ERIE COUNTY DEPARTMENT OF PUBLIC WORKS
OFFICE OF THE COMMISSIONER

Addendum No. 1

Project:
2025-956-02 SUNY ECC North Campus Kittinger Hall Boiler Room Upgrades (REBID)

Date: November 12, 2026

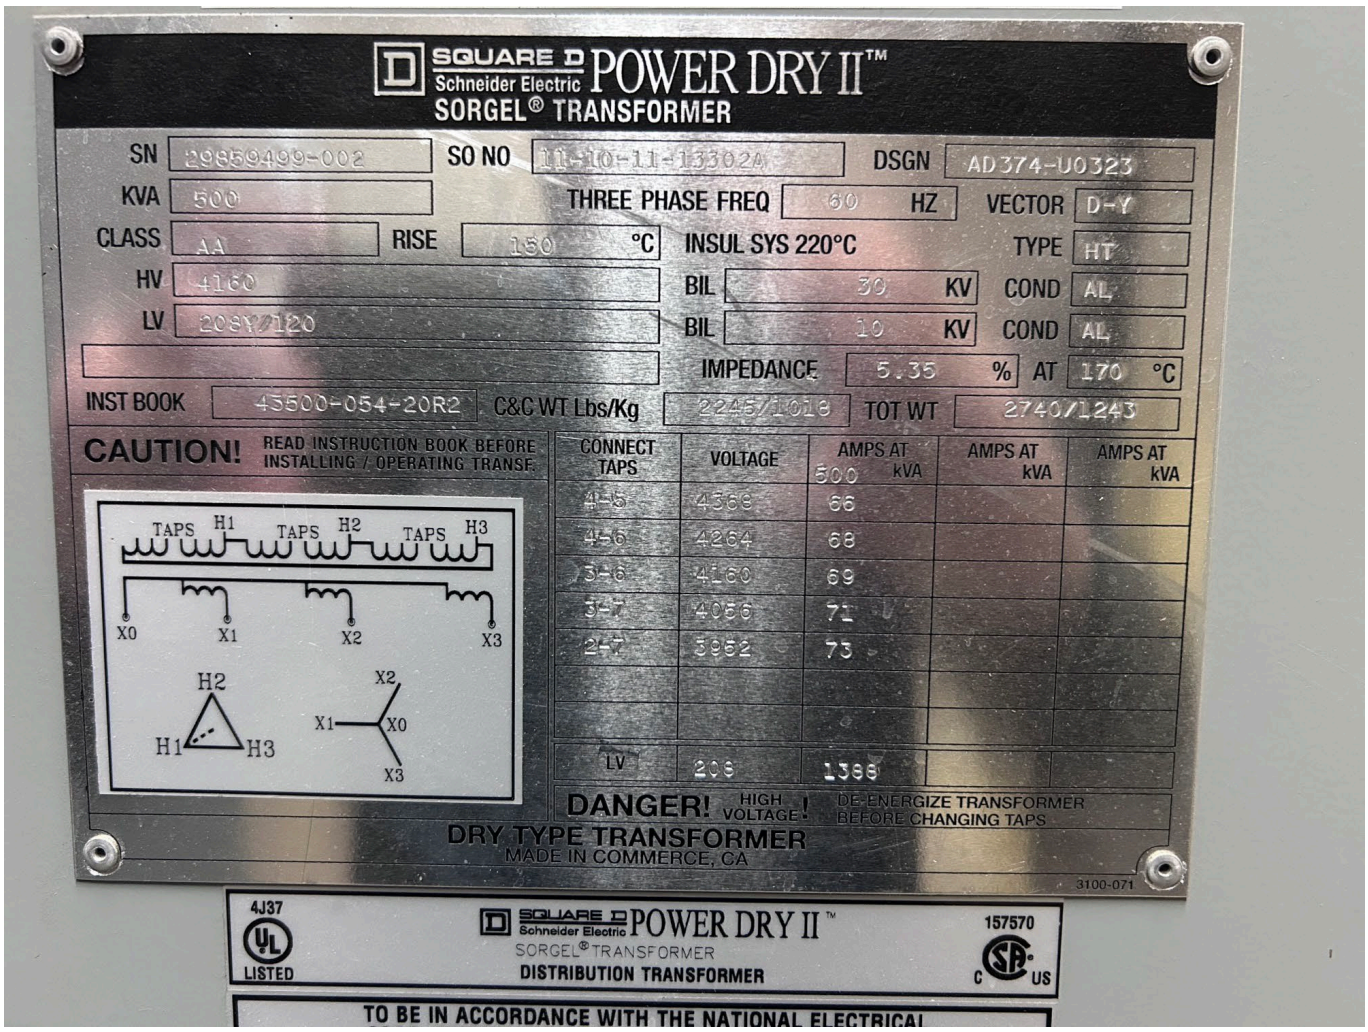
B. Question: I do not see anything in the transformer spec about the weight of the existing 500kvs transformer. Do you have a name plate for the transformer?

Response: The transformer is existing to be relocated as called for on the drawings, not specification. The transformer is a Square D, 5kV delta :120/208V Y secondary, dry type, NEMA 1 enclosure.

Dimensions:
W-50 1/2”
H-65 3/4”
D-32”

Refer to images below.
